**ATTACHMENT A**  
**BLM COMMENT RESPONSES**  
**WITH EXTENDED NARRATIVES**  
**MARCH 31, 2017**

**BLM GENERAL 5**

**Figure 5-20**  
**Colorado River at Lees Ferry Daily Mean and Range of Flow (1970-2016)**

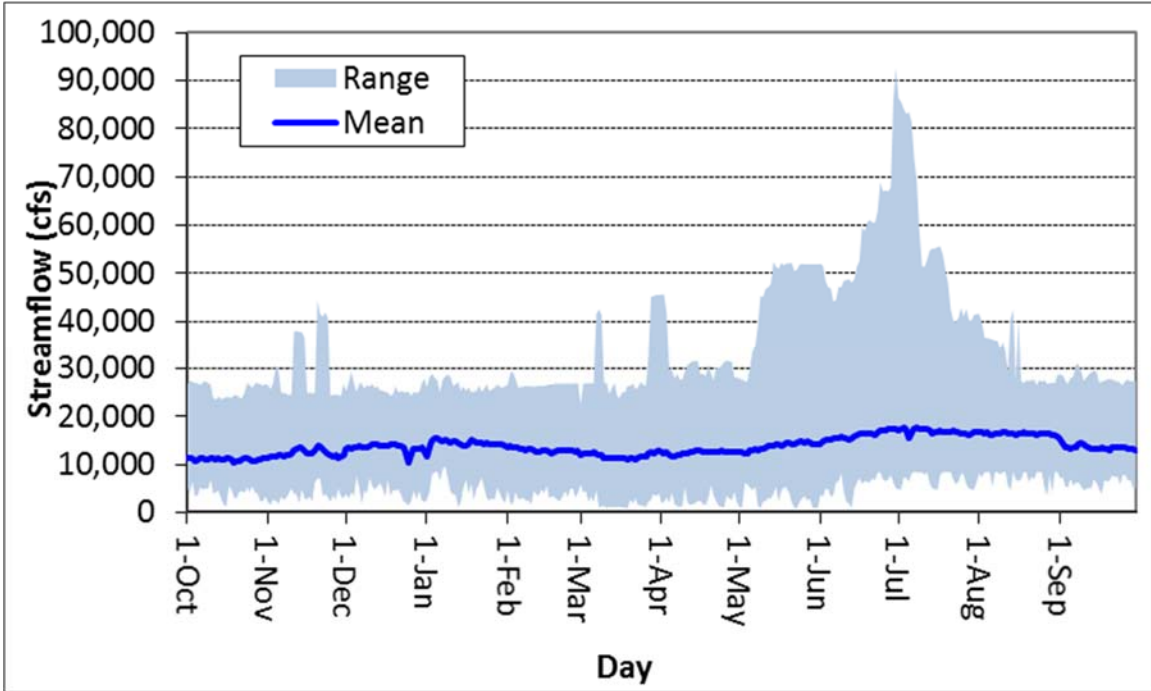
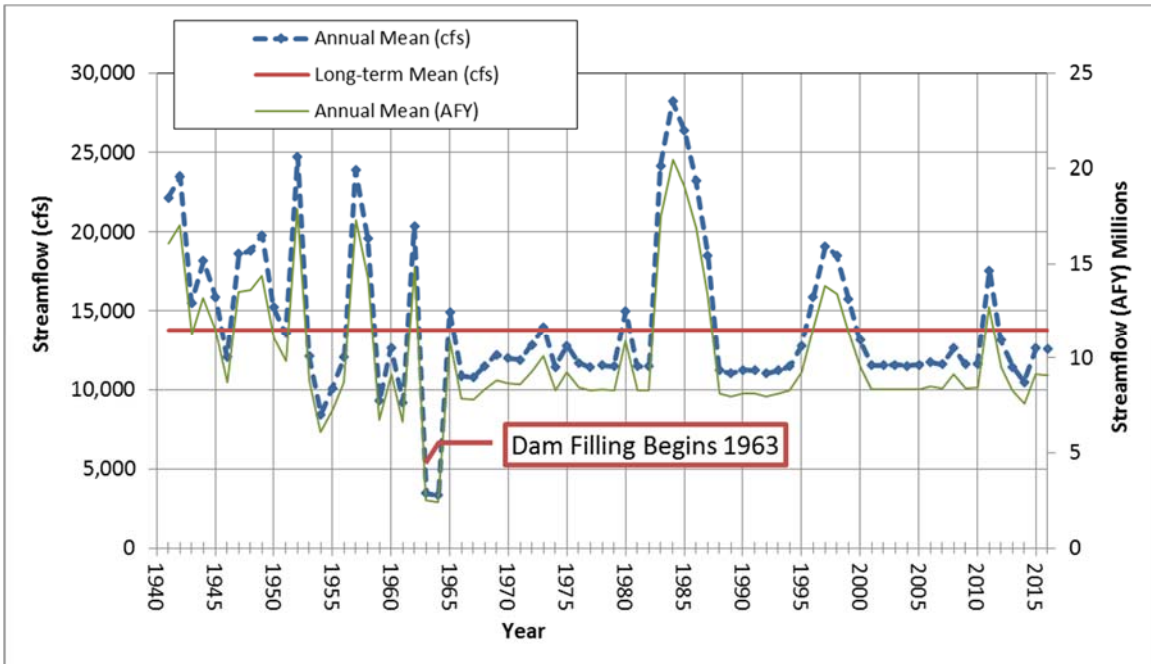
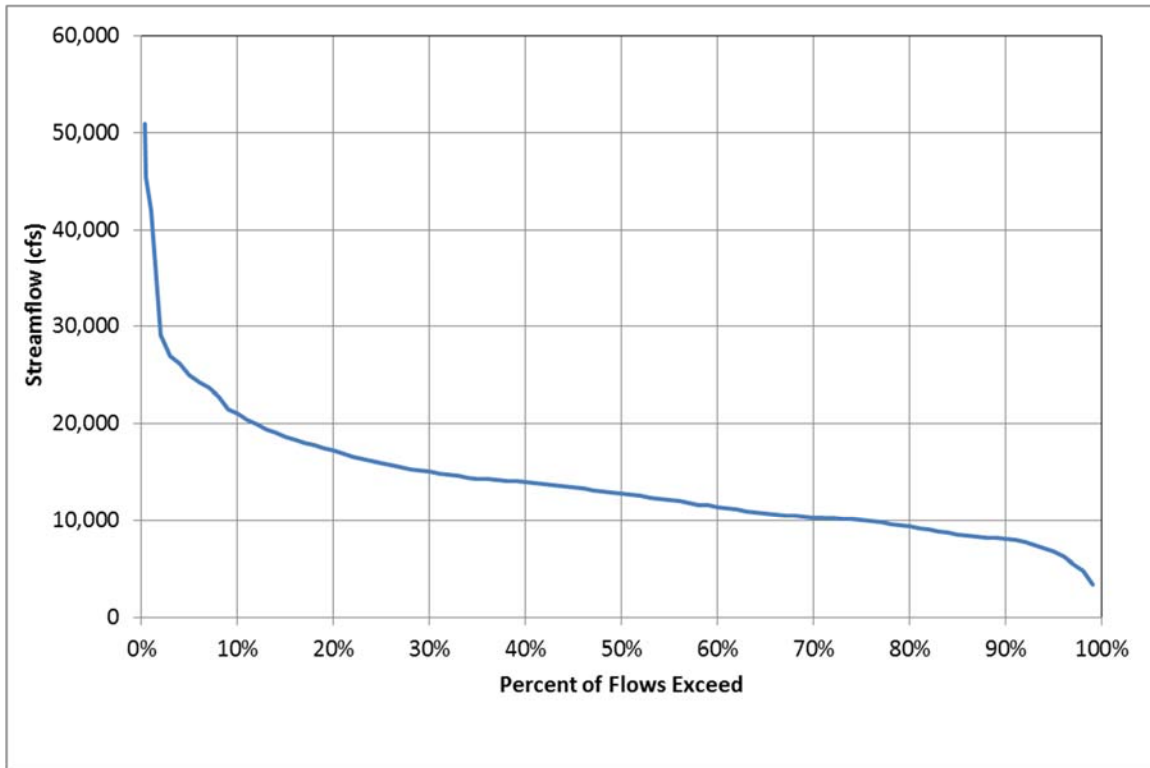
#### **BLM 589**

The Final License Application filed with FERC shows the figure in BLM Comment No. 589 as Figure 5-20. The updated Figure 5-20 displaying Mean Daily Flows for the Colorado River at Lees Ferry for the period 1970 through 2016 is shown below. Figure 5-21 displaying Annual Mean Flows for the Colorado River at Lees Ferry streamflow gage and Figure 5-22 displaying the Flow Exceedance Curve for the same location in the Final License Application is changed as a result of the updated data shown in Figure 5-20. Updated Figures 5-21 and 5-22 are provided below.

Figure 5-27A

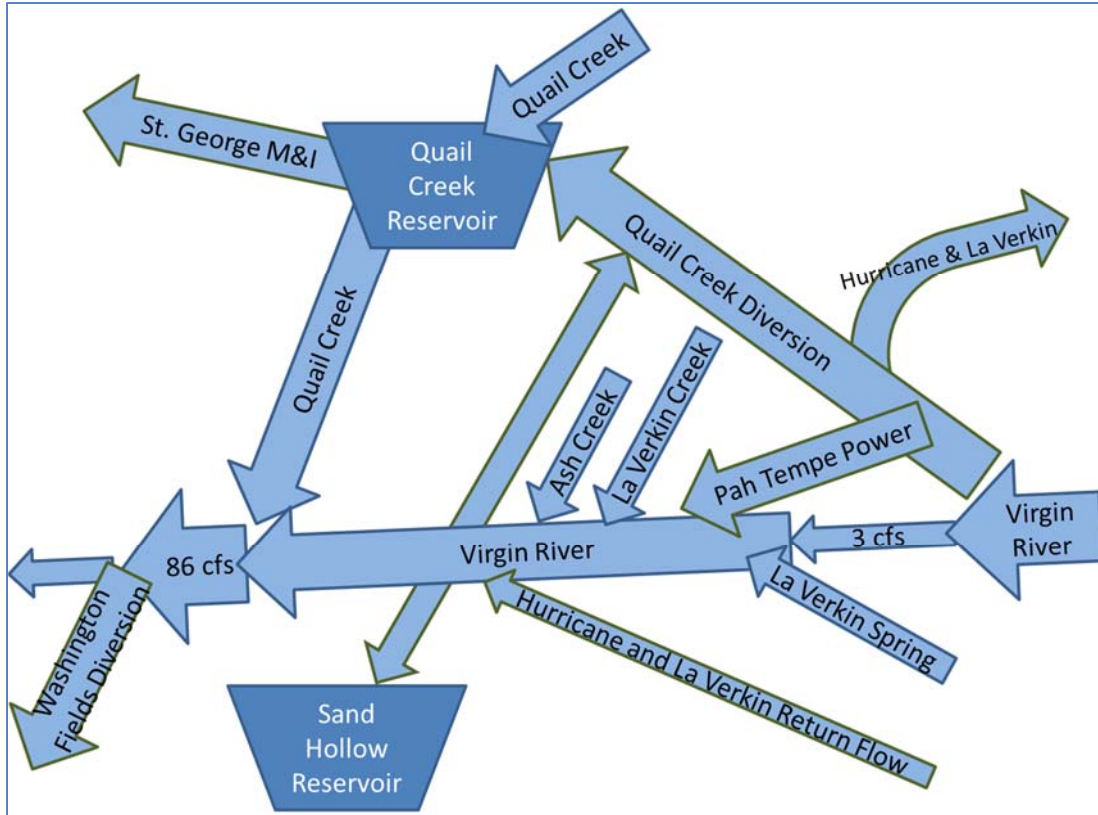
### **BLM 592**

Information on the flows between Quail Creek and Washington Fields is added. The following paragraph is added as the 3<sup>rd</sup> paragraph of and the following Figure 27A is added to section 5.3.3.1.2.2, Chapter 5, Exhibit E of the License Application: **Figure 5-27A is a schematic of the current Virgin River inflows and diversions between the Quail Creek Diversion and the Washington Fields Diversion. The 1982 biological opinion for the Quail Creek project recognized that the Virgin River flow regime was created by long-standing water rights that hold an 1890 priority. The 1982 biological opinion as well as subsequent biological opinions issued in 2001 (Virgin River Program), 2004 (Washington Fields Fish Screen), 2006 (Quail Creek Diversion Sluicing Program), 2012 (Washington Fields Road Bridge Repair), 2013 (Stateline Fish Barrier and UDOT I-15 Bridge) and 2014 (Mall Drive Bridge) have all recognized that flows in the Virgin River below the QCD are based upon the “Washington Fields water right [that] requires a minimum flow of 86 cfs (or the natural flow of the river) to the Washington Fields Diversion.” A flow of 3 cfs is maintained downstream of the Quail Creek diversion point pursuant to the Spinedace Conservation Agreement (Utah Division of Wildlife Resources, U.S. Fish and Wildlife, U.S. Bureau of Land Management, National Park Service, Nevada Division of Wildlife, Washington County Water Conservancy District, Arizona Game and Fish Department. 1995. Conservation Agreement and Strategy for Virgin Spinedace (*Lepidomeda mollispinis mollispinis*). April 1995).**

**Figure 5-33**  
**Virgin River at Virgin, Annual Mean Flows**

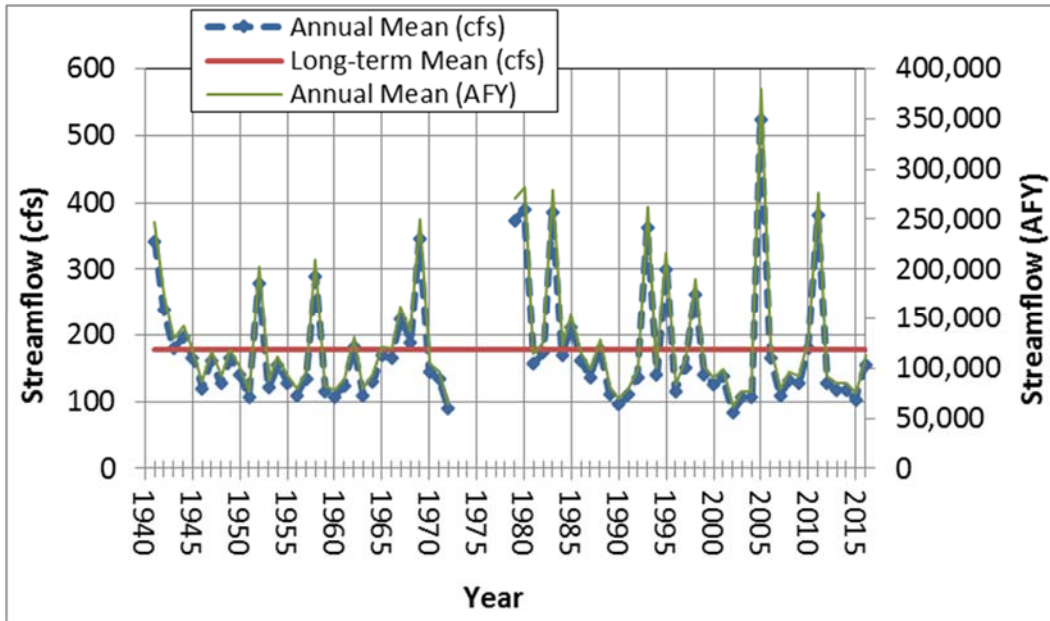
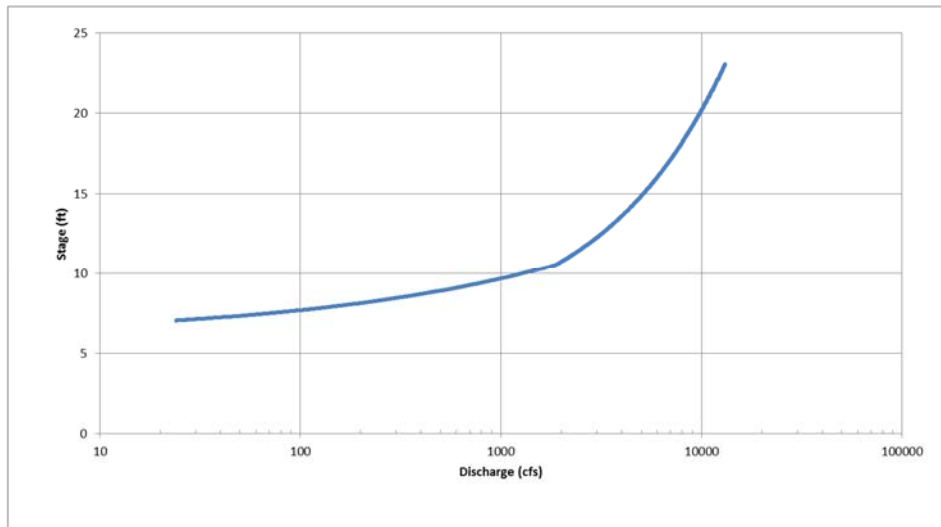
**BLM 595**

The Final License Application filed with FERC shows the figure in BLM Comment No. 595 as Figure 5-33. The text referencing the reader to Figure 5-33 is changed to read as follows: **The long term annual mean streamflow is 178 cfs.** The updated Figure 5-33 displaying Virgin River at Virgin, Annual Mean Flows from 1940 through 2016 is shown below. Figure 5-34 in the Final License Application changed as a result of the updated data shown in Figure 5-33. The updated Figure 5-34 is shown below.

**Figure 5-38**  
**Virgin River near St. George Flow Exceedance (1992 - 2016)**

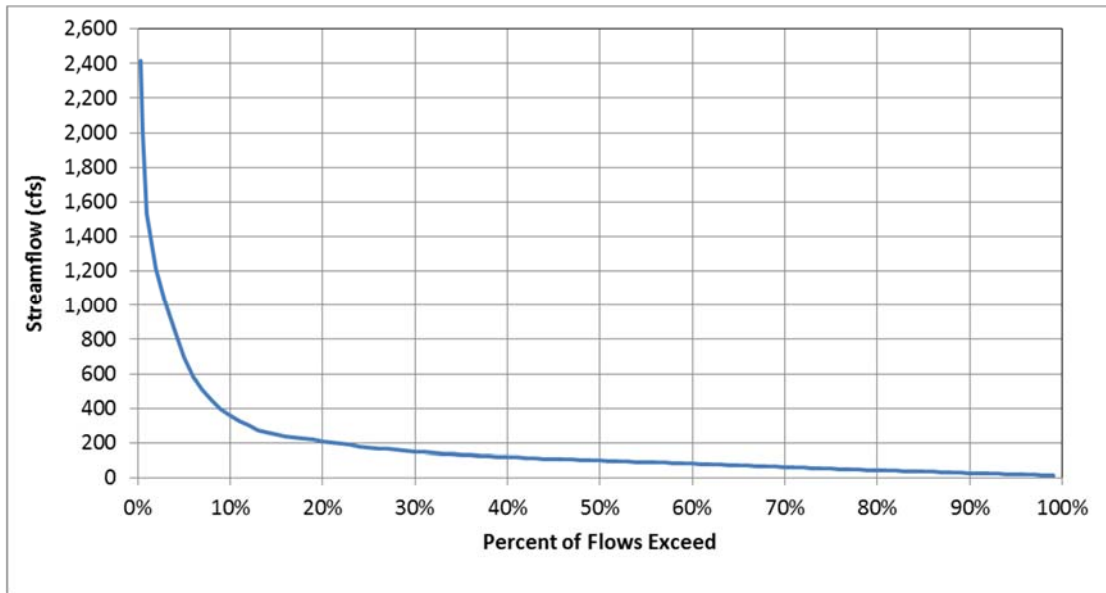
**BLM 596**

The Final License Application filed with FERC shows the figure in BLM Comment No. 595 as Figure 5-38. The text referencing the reader to Figure 5-38 is changed to read as follows: **Figure 5-38 shows the flow exceedance curve for the Virgin River near St. George for the period 1992 through 2016. The 90 percent exceedance value is 21 cfs while the 10 percent exceedance value is 331 cfs. The median**

**flow is 96 cfs.** The updated Figure 5-38 displaying the flow exceedance curve for the Virgin River near St. George for the period 1992- 2016 is shown below.

**Figure 5-36**  
**Virgin River near St. George, Daily Flows**

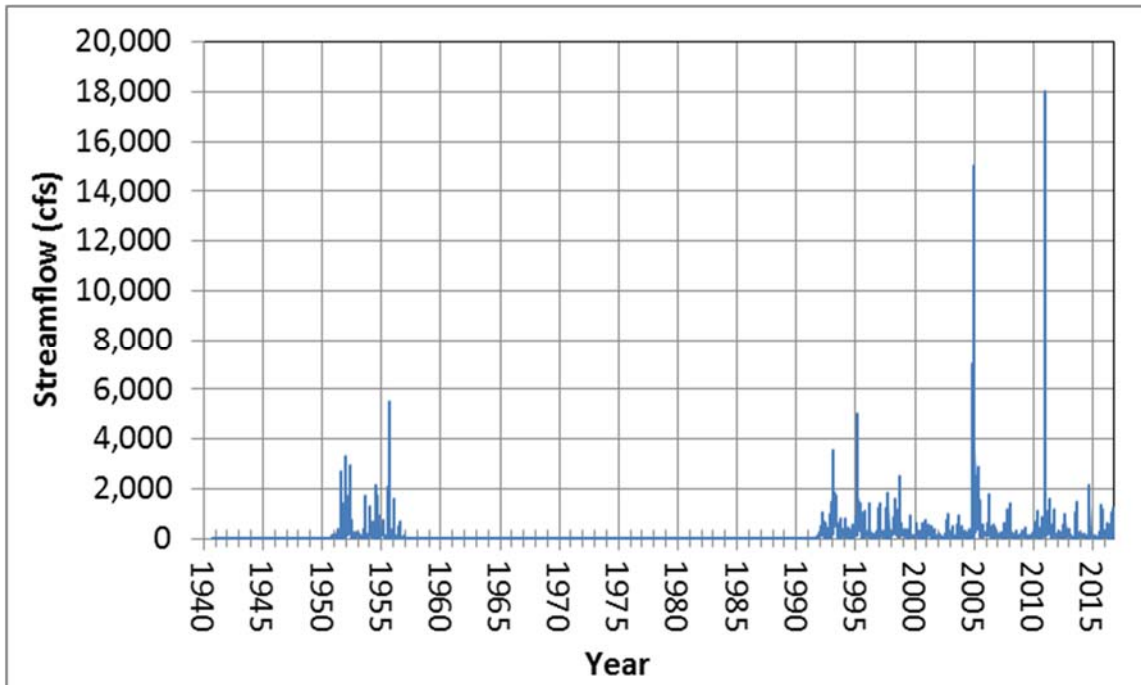
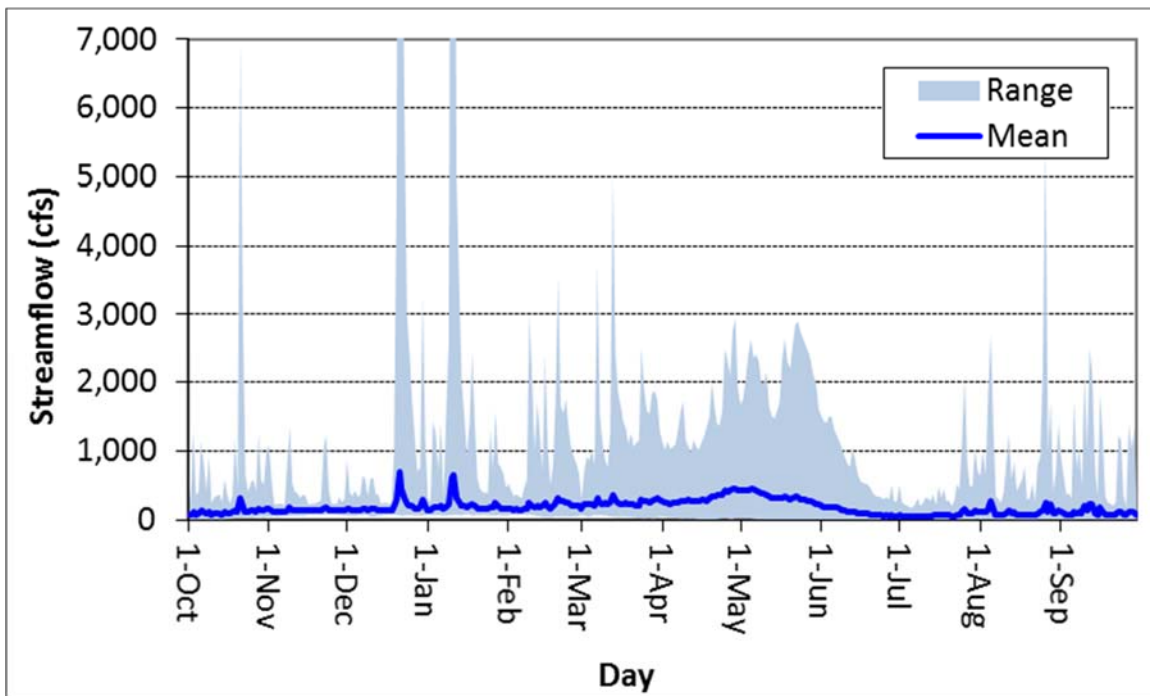
### **BLM 597**

The Final License Application filed with FERC shows the figure in BLM Comment No. 597 as Figure 5-36. The text referencing the reader to Figure 5-36 is changed to read as follows: **As shown in the daily streamflow chart in Figure 5-36, the period of record for this gage shown in the table is from 1940 through 2016.** The updated Figure 5-36 displaying Mean Daily Flows for the Virgin River near St. George for the period 1940 through September 30, 2016 is shown below. Figure 5-37 in the Final License Application changed as a result of the updated data shown in Figure 5-36. The updated Figure 5-37 is shown below.

**Figure 5-39**  
**Virgin River near St. George Monthly Mean Flows (1992 - 2016)**

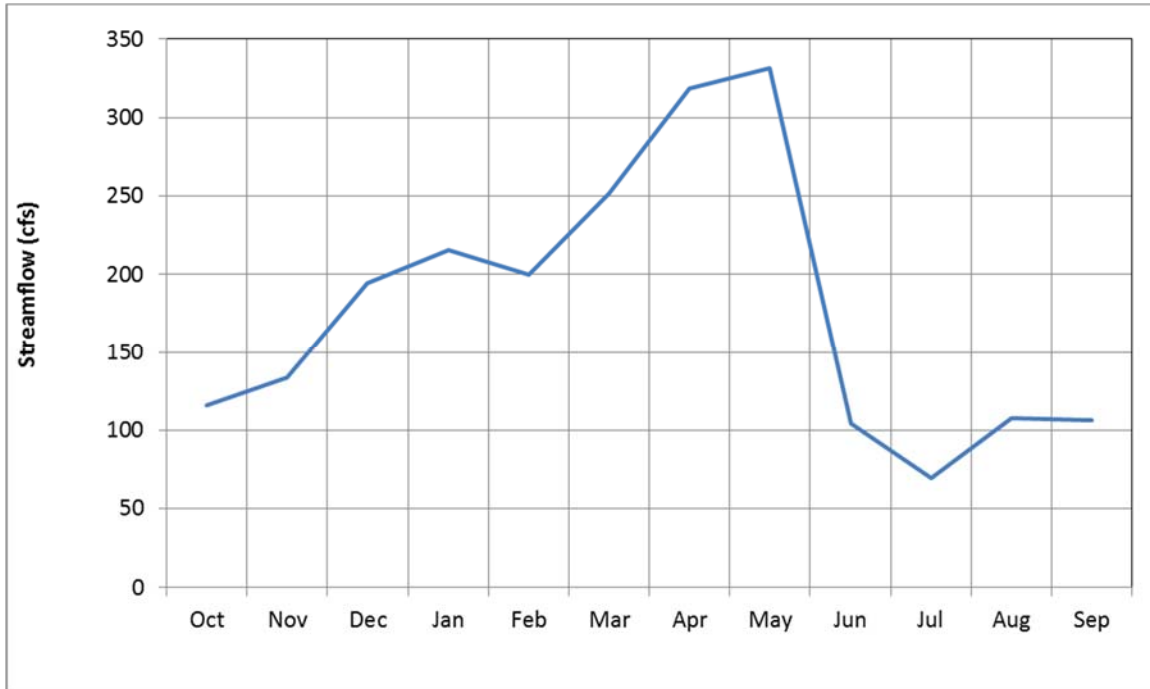
**BLM 599**

The Final License Application filed with FERC shows the figure in BLM Comment No. 599 as Figure 5-39. The text referencing the reader to Figure 5-39 is changed to read as follows: **Figure 5-39 depicts monthly mean flows for the Virgin River near St. George, Utah gage for the period of 1992 through 2016.** The updated Figure 5-39 displaying Monthly Mean Flows for the Virgin River near St. George for the period 1992 through 2016 is shown below.

**Figure 5-40**  
**Virgin River near St. George Annual Mean Flows**

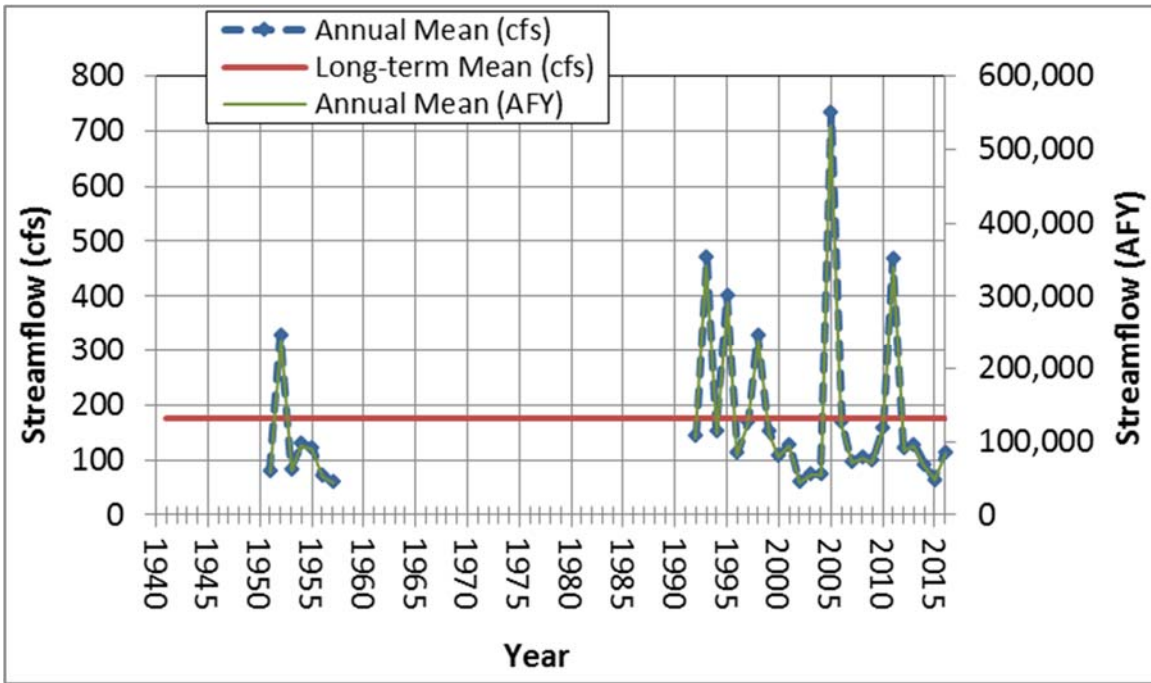
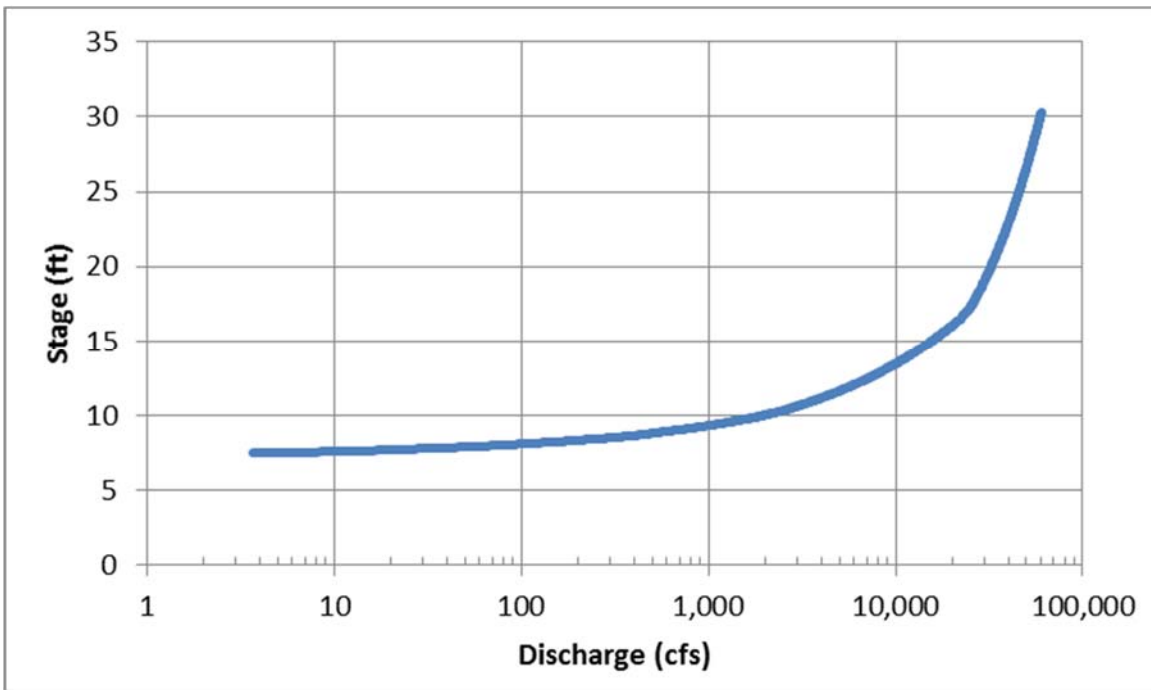
**BLM 600**

The Final License Application filed with FERC shows the figure in BLM Comment No. 600 as Figure 5-40. The text referencing the reader to Figure 5-40 is changed to read as follows: **The long term annual mean streamflow is 176 cfs.** The updated Figure 5-40 displaying Virgin River near St. George, Annual Mean Flows from 1940 through 2016 is shown below. Figure 5-41 in the Final License Application changed as a result of the updated data shown in Figure 5-40. The updated Figure 5-41 is shown below.
